ISO/IEC TS 29125

AMENDMENT 1

Information technology – Telecommunications cabling requirements for remote powering of terminal equipment

ISO/IEC TS 29125:2017-04/AMD1:2020-05(en)

Figure 3 – Temperature rise for a 0,57 mm conductor diameter 1-pair cable versus current for different bundle sizes in air

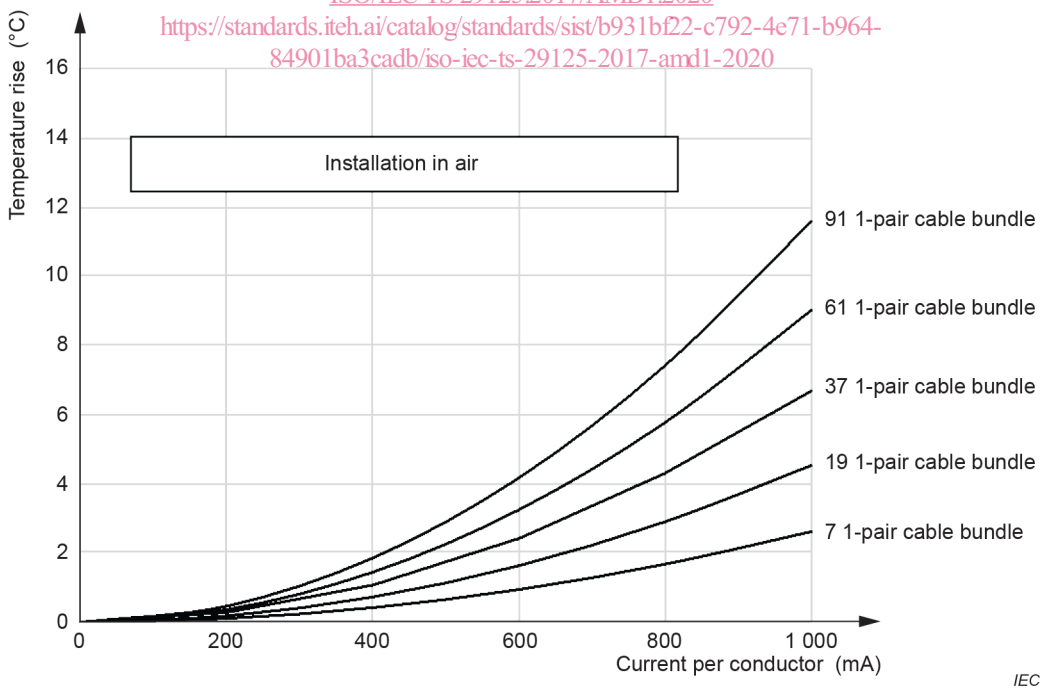
Table 8 shows the effect of energizing the number of pairs within a 37-cable bundle for different 1-pair cable constructions in air. Figure 1 shows this data in graphical form.

Insert the following new Figure 3 after Table 8:

Figure 4 – Temperature rise for a 0,57 mm conductor diameter 1-pair cable versus current for different bundle sizes in conduit

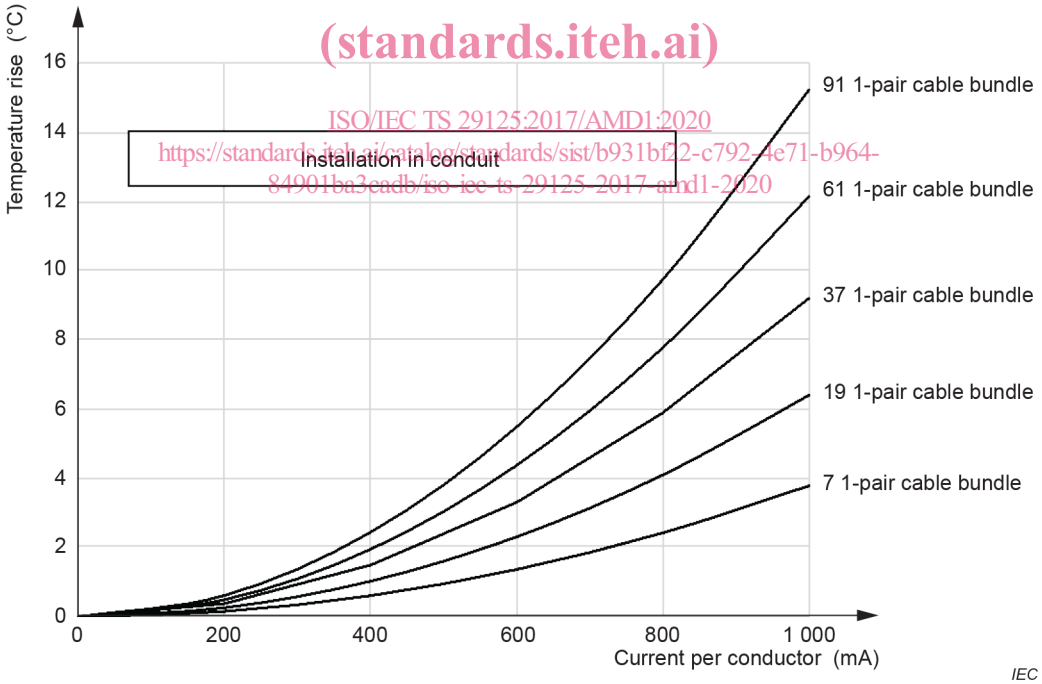
Table 9 shows the effect of energizing the number of pairs within a 37-cable bundle for different 1-pair cable constructions in conduit. Figure 2 shows this data in graphical form.

Insert the following new Figure 4 after Table 9:
